Reply to Office Action of February 6, 2008

AMENDMENTS TO THE DRAWINGS:

U.S. Reissue Application No.: 09/986,720 Inventor: Thierry PONTON Attorney Docket No.: 5725.0867 Reply to Office Action of February 6, 2008

FIG.3A

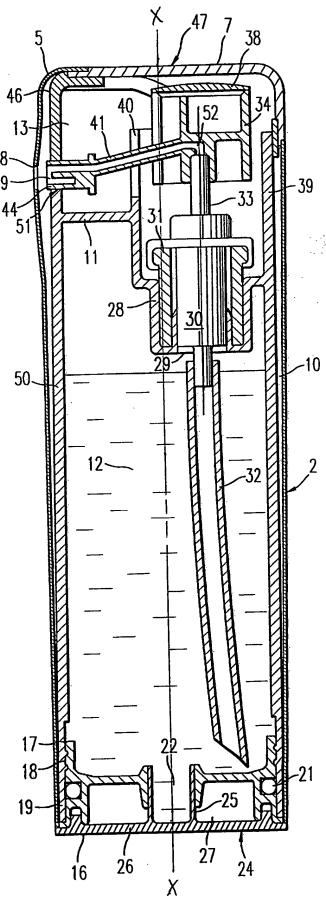
Please amend Fig. 3A to show an axis X of the container and an axis of the

pump 30, as shown in red ink on the attached drawing sheet labeled "Annotated

The drawings were objected to, allegedly because "the axis of said container and in a direction such that the axis of said pump is farther from the product outlet than is the axis of said container," a version of which is recited in claims 8, 28-30, 43, 55, 70, 90, and 91, is not shown in the drawing figures. Office Action at 2-3. By this Amendment, Applicant has amended Fig. 3A to show an axis X of the container and an

axis of the pump 30, as shown in red ink on the attached drawing sheet labeled "Annotated Marked-up Drawing." This amendment is incorporated in the attached "Replacement" drawing sheet containing amended Fig. 3A, which has been labeled "Amended." Support for these amendments to the drawings is found at least at column 5, line 64 through col. 6, line 3 of the patent.
